**ADDENDUM NO. 2**

**PROJECT NAME:** East Stadium Bid Package 5  
**UNL PROJECT NUMBER:** C049P136

DATE OF ISSUANCE: January 9, 2012  
DATE OF BID OPENING: January 11, 2012

**5 SUITE 438E**  
SCALE: 3/8" = 1'-0"

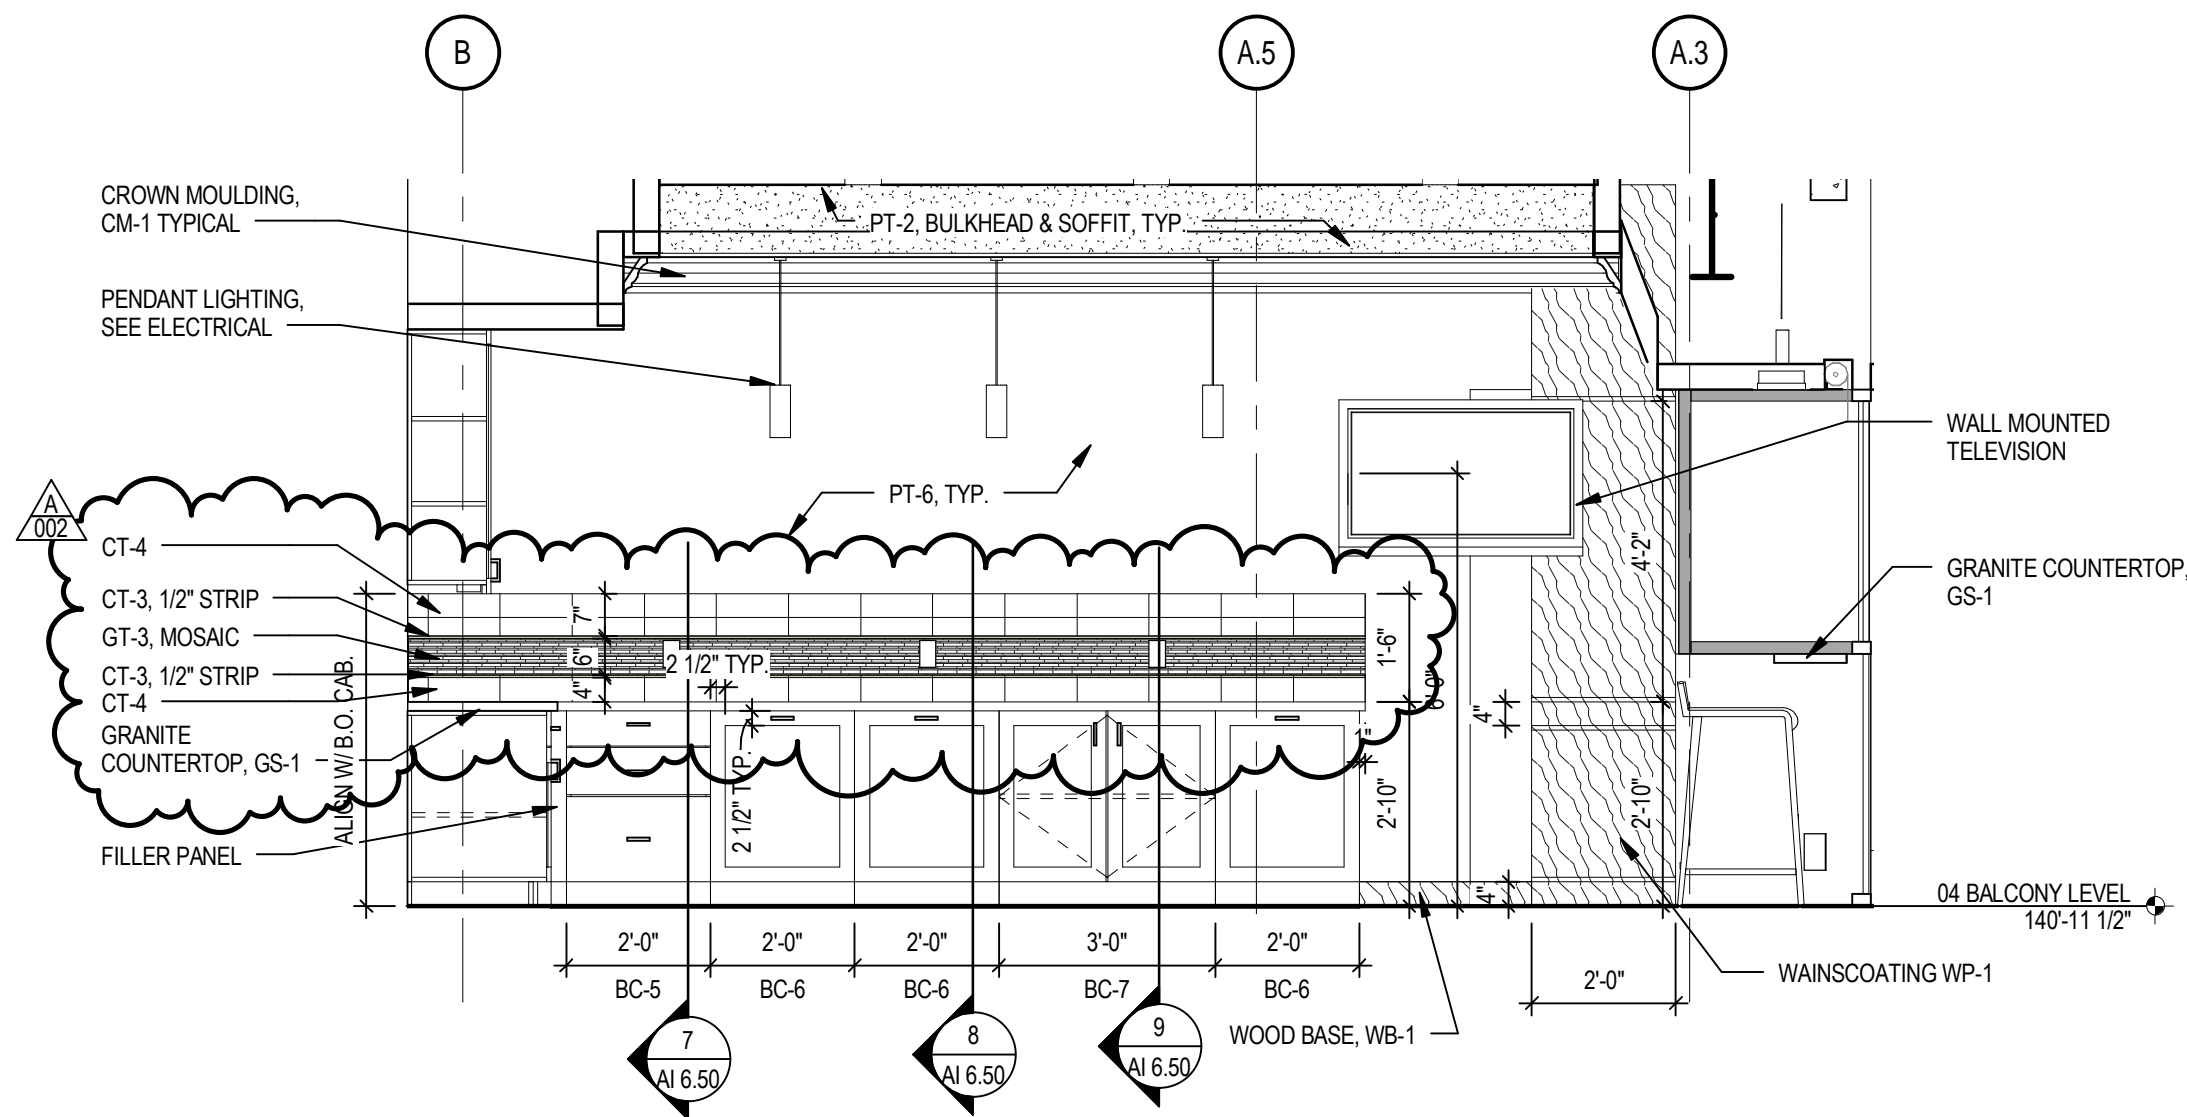
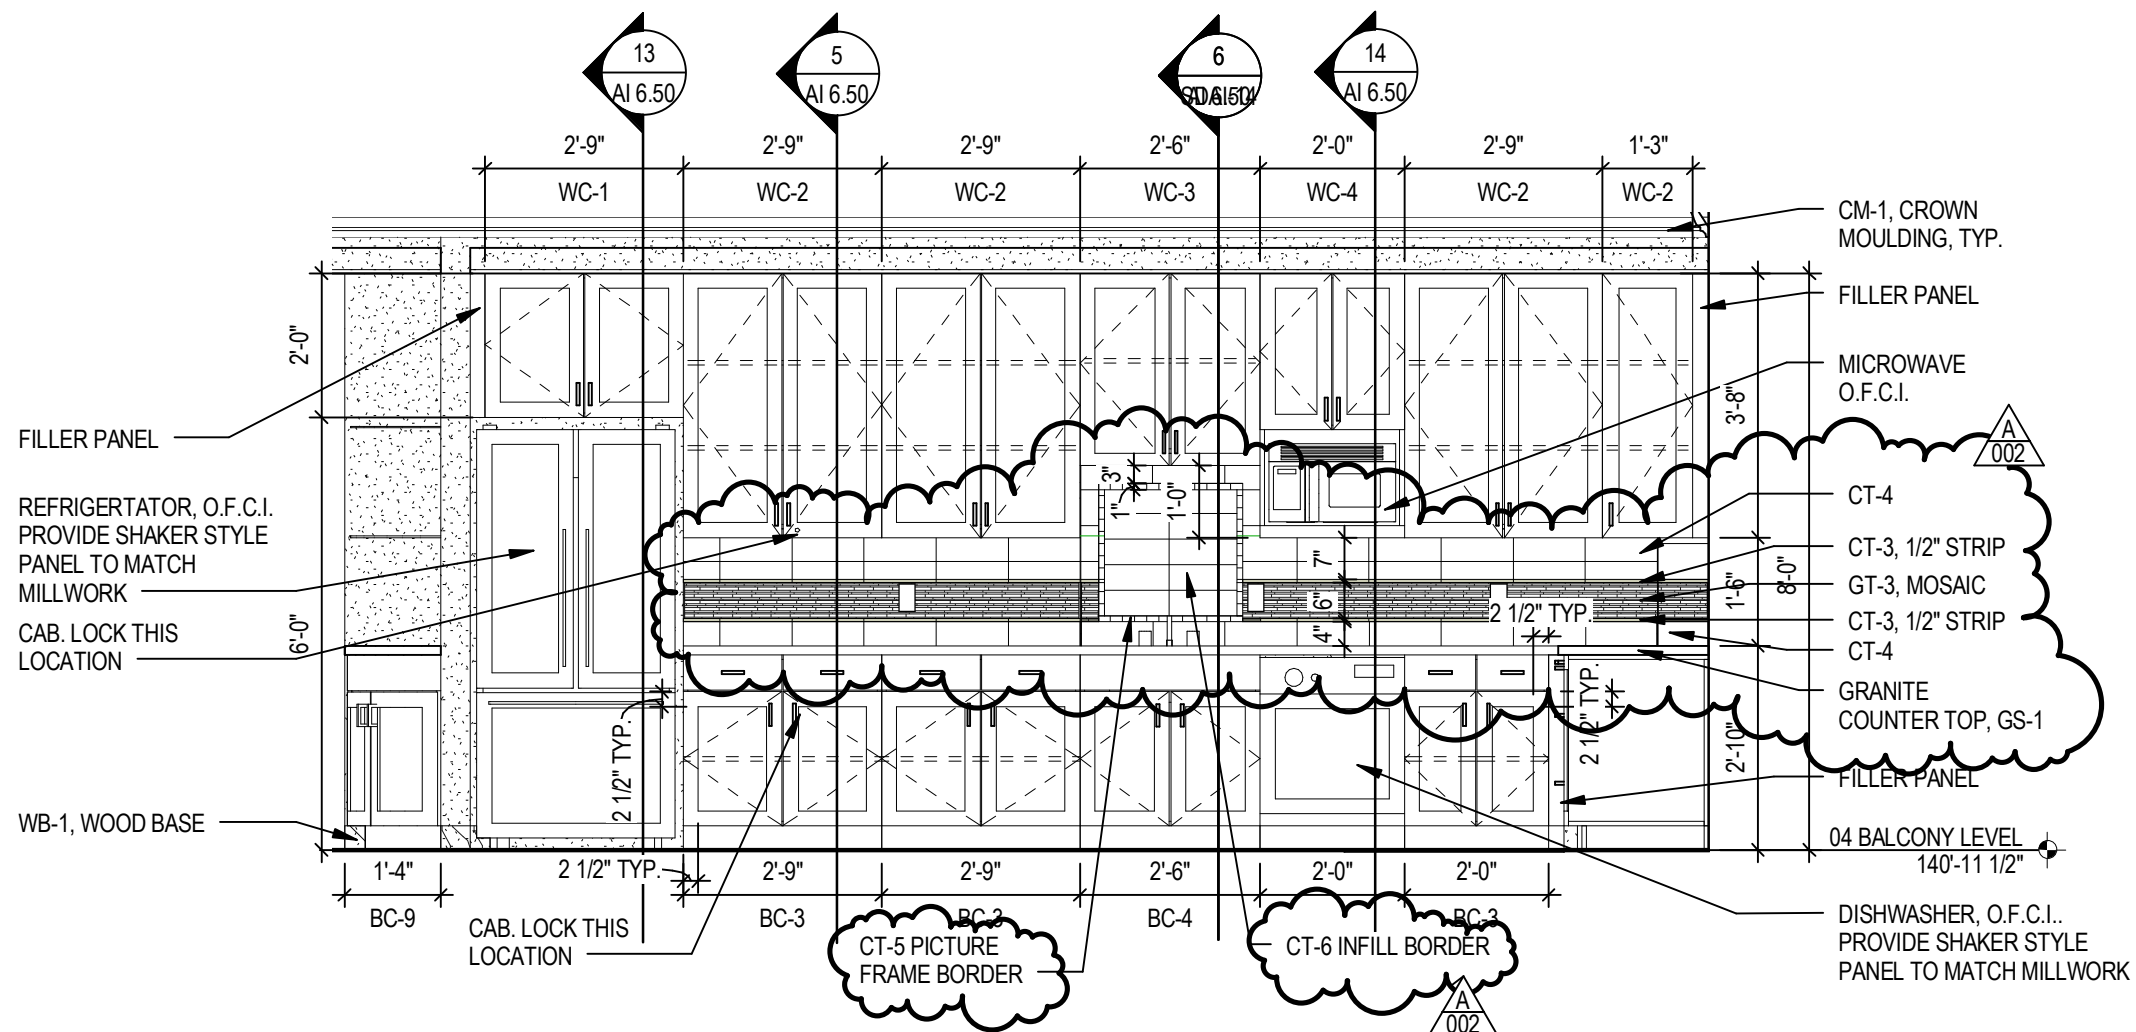
- a. Refer to detail 5 on supplemental drawing SDAI-12 for typical tile finish detail changes in balcony level suites.
- b. Refer to detail 6 on supplemental drawing SDAI-13 for typical tile finish detail changes in balcony level suites.

**NOTE: Revised tile typical at Suites 438A, 438B, 438C, 438D, 438E**
